Access Compliance Report

(Curb Ramps)

Intersection ID: 10026804	Main Street: FOREST_POINT_CR	Cross Street: N/A	Location: SE
ADA ID: 1B7FF090D2DF	Ramp Type: PerpDiag	Initial Pass/Fail: Fail	Overall Compliance: No
Severity Score: 22.5			
Codes/Mitigation Info/Possible Solution		Field Measurements/Component Compliance

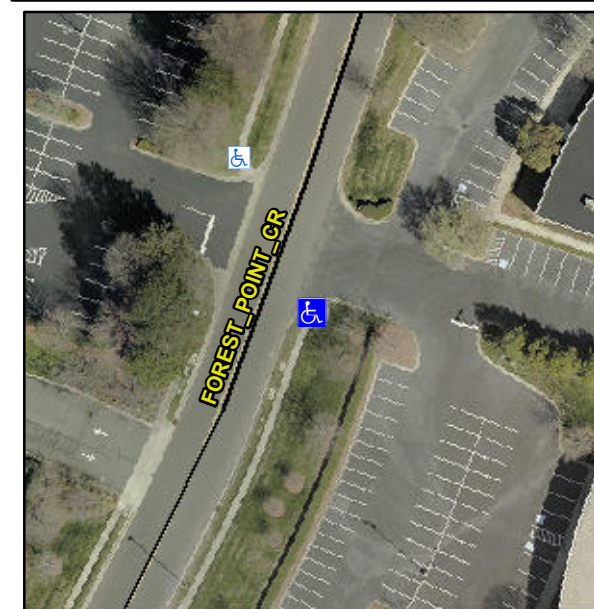
Not Found, R304.5.1, R304.2.2, R304.5.3

Compliance	Description	Data	Compliance	Description	Data
N/A	Ramp Length (in)	68.0	No	Ramp Slope (%)	10.1
No	Ramp Width (in)	38.0	No	Ramp XSlope (%)	2.8
N/A	Flare Type LT	N/A	N/A	Flare Type RT	N/A
N/A	Flare Slope LT (%)	N/A	N/A	Flare Slope RT (%)	N/A
N/A	Flare Traversable LT?	N/A	N/A	Flare Traversable RT?	N/A
N/A	Landing Length (in)	N/A	N/A	DWS Provided?	N/A
N/A	Landing Width (in)	N/A	N/A	DWS Contrast?	N/A
N/A	Landing Slope (%)	N/A	N/A	DWS Length (in)	N/A
N/A	Landing X Slope (%)	N/A	N/A	DWS Full Width?	N/A
N/A	Landing Curb? (Y/N)	N/A	N/A	DWS Offset (in)	N/A
N/A	Shared Landing?	N/A			
N/A	Gutter Ponding?	N/A	N/A	Gutter Slope (%)	N/A
N/A	Gutter Lip Ht (in)	N/A	N/A	Gutter X Slope (%)	N/A
N/A	Painted X Walk1?	No	N/A	Painted X Walk2?	No
	X Walk 1 Direction	To NE		X Walk 2 Direction	To NW
N/A	X Walk 1 Width (in)	N/A	N/A	X Walk 2 Width (in)	N/A
	X Walk 1 Slope (%)	4.2		X Walk 2 Slope (%)	1.2
	X Walk 1 X Slope (%)	1.7		X Walk 2 X Slope (%)	2.1

Remove & Replace Curb Ramp With Two New Directional Ramps or Equivalent.
